CALIFORNIA COASTAL COMMISSION

**Tu 10c****STAFF REPORT AND RECOMMENDATION****ON CONSISTENCY DETERMINATION**

Consistency Determination No.	CD-084-99
Staff:	LJS-SF
File Date:	8/6/99
45th Day:	9/20/99
60th Day:	10/5/99
Commission Meeting:	9/14/99

Construction of a 2,800-foot-long, six-foot-high compacted-fill flood control berm along the southern boundary of existing residential development and north of the Tijuana River.

EXHIBIT NO. 3
APPLICATION NO.
CD-84-99
California Coastal Commission

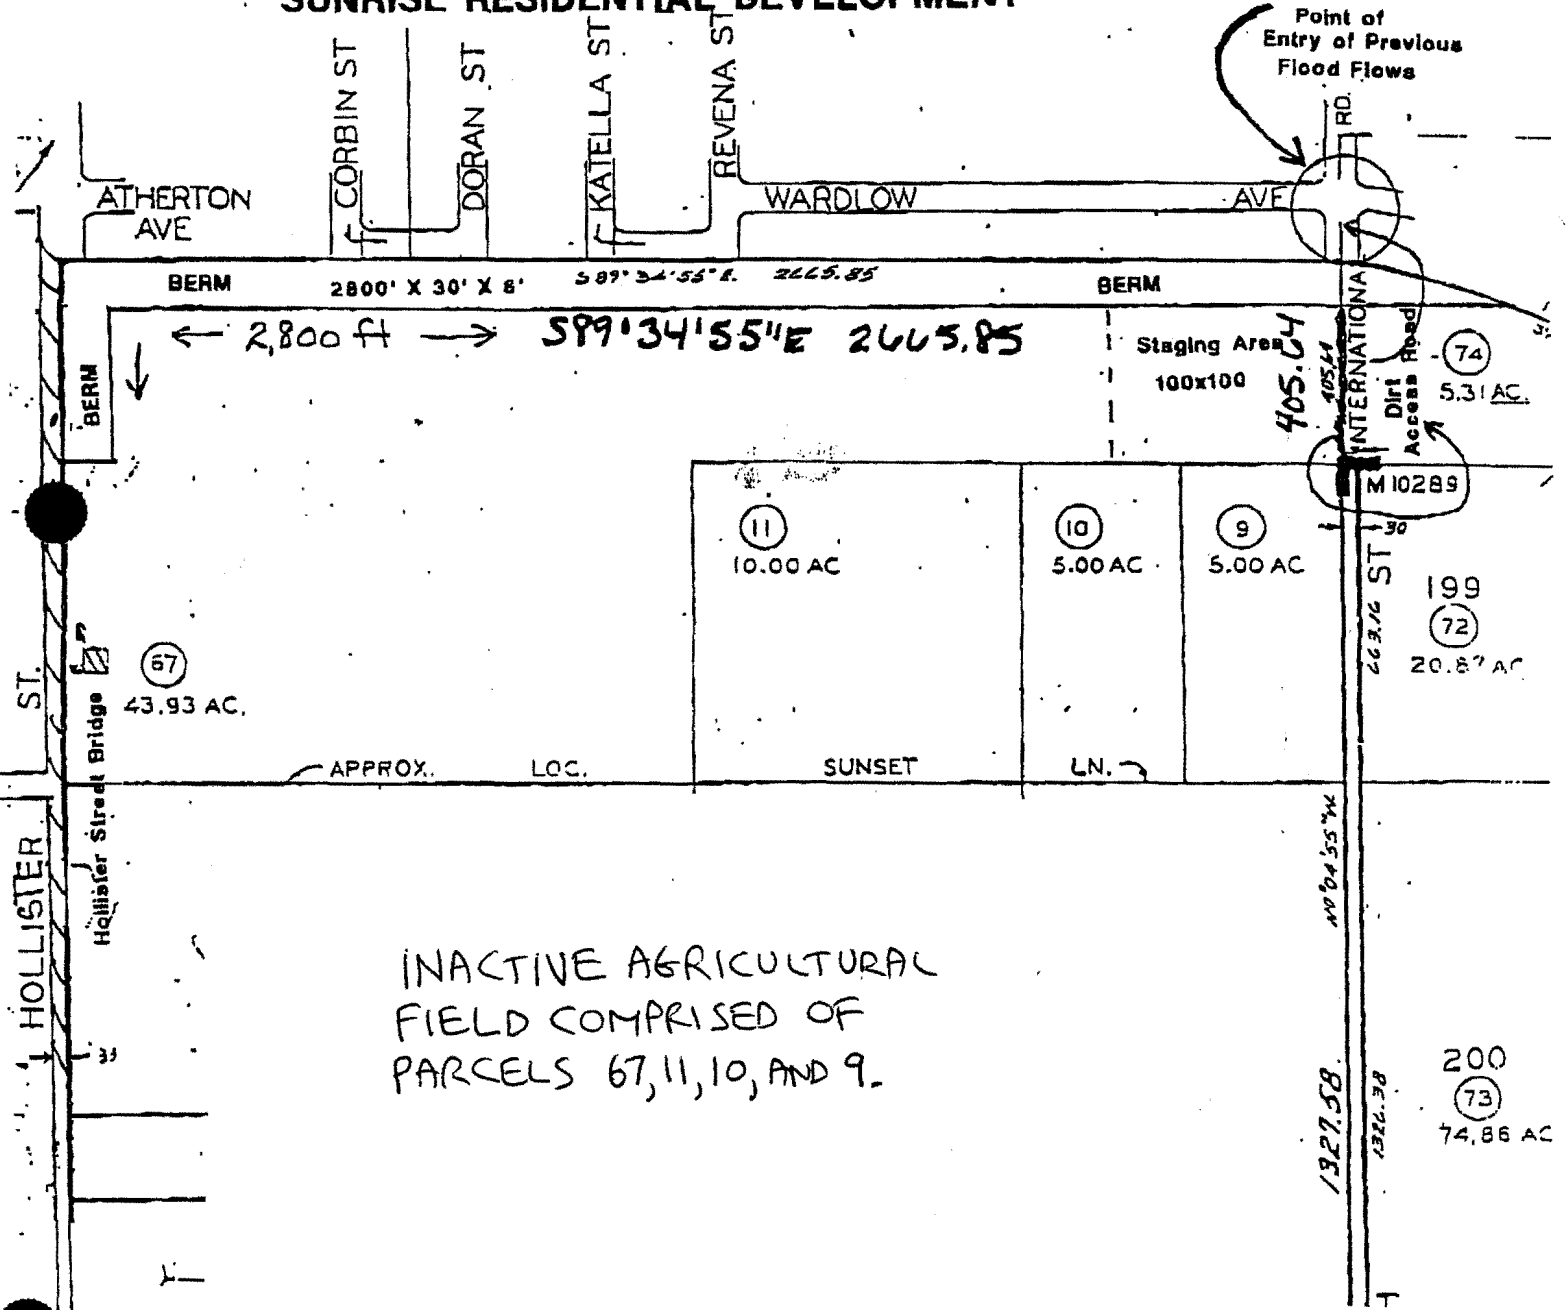
The proposed berm would be constructed along an existing, south-facing, four-foot-high earthen embankment that separates a currently inactive agricultural field and the Sunrise residential development. The 2,800-foot-long, 30-foot-wide (at the base) earthen berm would be constructed primarily along the northern perimeter of the field; however, at the northwest corner

the berm would turn south for approximately 300 feet until intersecting existing high ground along Hollister Street (Exhibit 3). The berm would have a total footprint of two acres and be situated on prime agricultural soil. The presence of the berm would reduce the amount of acreage available for future agricultural operations on the 64-acre field by three percent (two acres).

The Corps examined alternatives to the berm that would not use agricultural lands or a reduced amount of land and determined that these alternatives are infeasible due to economic or environmental factors, or both. However, the Corps did not examine the construction of a floodwall instead of the proposed berm. The proposed berm requires a 2:1 slope and to achieve the necessary flood protection. It is this slope that results in a loss of prime agricultural soils. On the other hand, a floodwall would be vertical and could be constructed without a loss of prime agricultural soils. Therefore, the proposed berm is inconsistent with Section 30241's requirement to maintain the maximum amount of prime agricultural land. Additionally, the proposed project, which provides protection for an urban land use, is an inconsistent conversion of prime agricultural land. Section 30241(d) requires the development of lands not suited for agriculture prior to conversion of agricultural land. Since the vertical wall could be constructed entirely on non-agricultural lands, the proposed berm would convert agricultural land unnecessarily. Therefore, the proposed project does not meet the requirement of using non-agricultural land prior to converting agricultural land.

In conclusion, the Commission finds that the proposed flood control berm has not been designed to minimize agricultural impacts and is, therefore, inconsistent with the agricultural protection

1. Design a floodwall to provide protection to the adjacent subdivision.
